Agenda Item # 12

SUB-003722-2026

Pecan Ridge Estates Subdivision

- Subdivision approval to create four (4) legal lots of record from one (1) legal lot of record.

DETAIL SITE PLAN

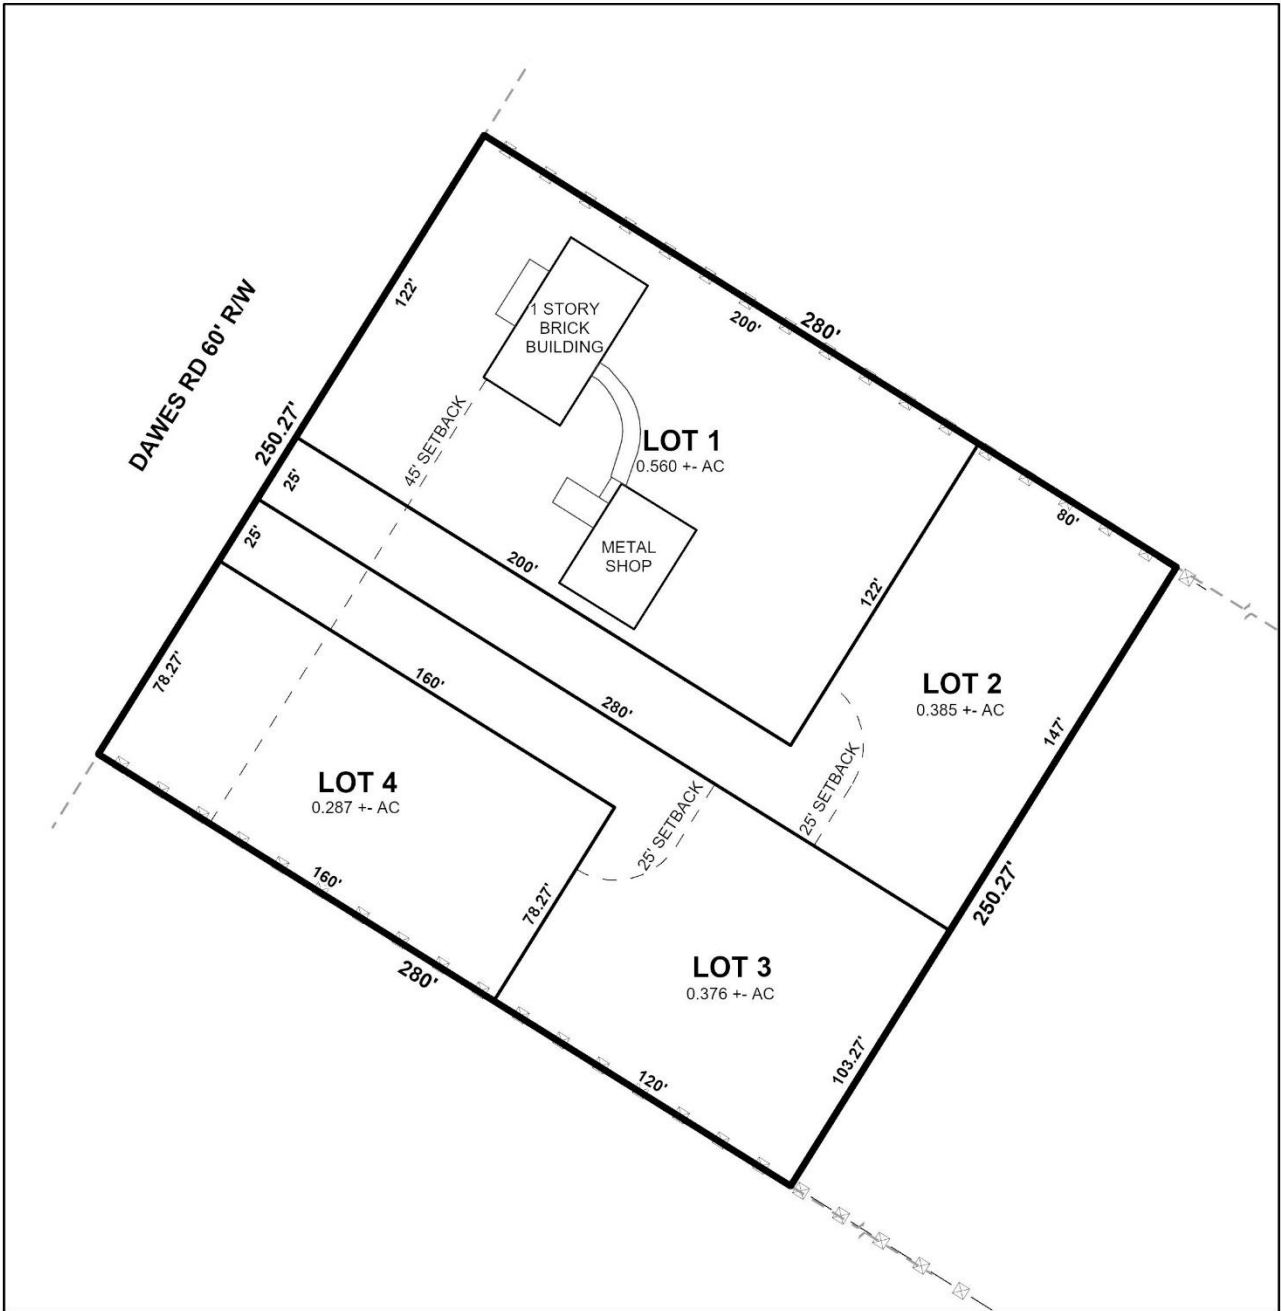
The proposed lots front Dawes Road, a Minor Arterial Street with a planned 100-foot right-of-way at this location. While the preliminary plat depicts an existing 60-foot right-of-way, the Planning Commission previously approved an increased 45-foot front yard setback in lieu of additional right-of-way dedication. The same 45-foot front yard setback is proposed with this application and may again be appropriate as an alternative to additional dedication. Should the Commission determine that additional dedication is unnecessary, a waiver of Section 6.B.9. of the Subdivision Regulations will be required.

Proposed Lots 1 and 4 exceed the minimum 60-foot lot width requirement along Dawes Road, as prescribed by Section 6.C.2.(b)(4) of the Subdivision Regulations for residential lots within the Suburban Sub-District. Proposed Lots 2 and 3, however, are designed as flag-shaped lots, each providing a 25-foot-wide pole along the street frontage. Such lot configurations are generally discouraged by Section 6.C.9. of the Subdivision Regulations except in unusual circumstances or in areas where varied and irregular lot patterns are common. Flag-shaped lots are not characteristic of the surrounding area, and no unusual site conditions appear to exist that would necessitate the proposed design. Therefore, approval of the subdivision will require a waiver of Section 6.C.9. of the Subdivision Regulations.

In addition to the 45-foot front yard setback depicted along Dawes Road, 25-foot front yard setbacks are illustrated on the portions of the proposed flag-shaped lots that widen to at least 60 feet. The 25-foot setback is consistent with Article 2, Section 64-2-5.E. of the Unified Development Code (UDC) and Section 6.C.8. of the Subdivision Regulations for lots within the R-1, Single-Family Residential Suburban District. If approved, these setbacks should be retained on the Final Plat.

1. Retention of the 45-foot front yard setback on the Final Plat in lieu of additional right-of-way dedication;
2. Retention of the lot sizes in both square feet and acres as a label on the Final Plat, or provision of a table on the Final Plat providing the same information;
3. Retention of the 25-foot front yard setback along Dawes Road where Lots 2 and 3 are at least 60 feet wide, in compliance with Section 64-2-5.E. of the Unified Development Code and Section 6.C.8. of the Subdivision Regulations;
4. Compliance with all Engineering comments noted in this staff report;
5. Compliance with all Traffic Engineering comments noted in this staff report;
6. Compliance with all Urban Forestry comments noted in this staff report; and,
7. Compliance with all Fire Department comments noted in this staff report.
